SERVICE INFORMATION BULLETIN

Subject: CHANGE IN ALIGNING MARK ON FLYWHEEL

All J-Series Engines produced after January 1, 2007

Current	New
"O" type aligning mark	Drill-hole type aligning mark
13450-3890	13450-E0B40
13450-3840	13450-E0180
13450-3830	13450-E0B10
"O" MARK 	● "MARK (0.0197in)

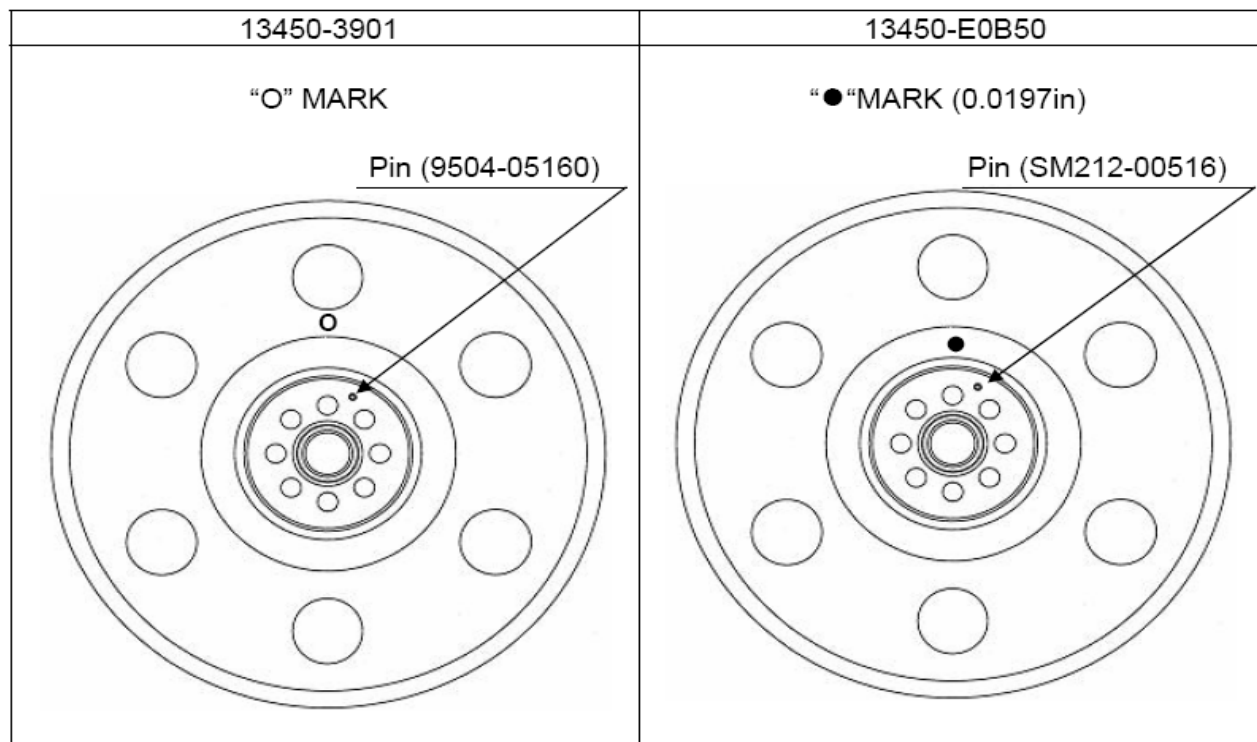
The stamped "O" aligning mark on the flywheel has been changed to a drilled aligning dimple with a diameter of 5mm x 0.5-1 mm in depth. This mark designates which bolt hole is enlarged on the engine-side of the flywheel. This enlarged hole is designed to fit over in the aligning collar found on the rear of the crankshaft

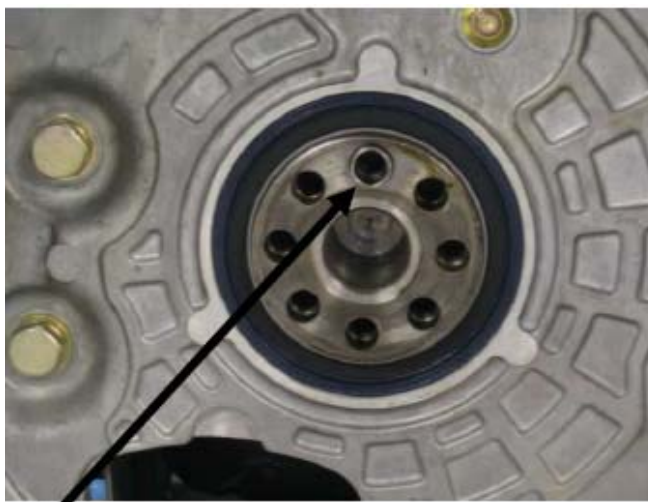
Enlarged hole to fit over collar

This enlarged hole is designed to fit over in the aligning collar found on the rear of the crankshaft

Alignment collar on rear of crankshaft
